**Proposal #24: 6999-07-89, WISC 2019 013**  
**C Wisconsin Rapids, E Grand Avenue**  
**3rd Street To 8th Street**  
**LOC STR**  
**Wood County**

This is Addendum No. 01, which provides for the following:

**ADDENDUM NO. 01**

**6999-07-89**

**LIGHT UNIT WISCONSIN RAPIDS DETAIL**  
NO SCALE

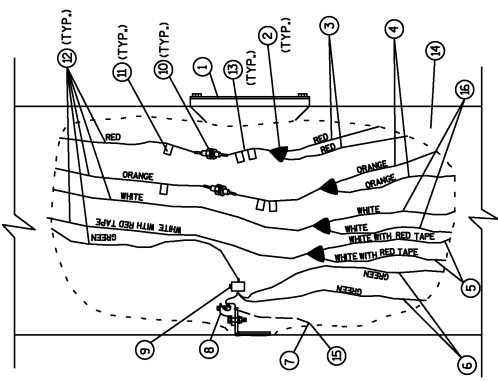
Revised Plan Sheets	
Plan Sheet	Plan Sheet Title (brief description of changes to sheet)
16	Revised "Light Unit Wisconsin Rapids Detail"
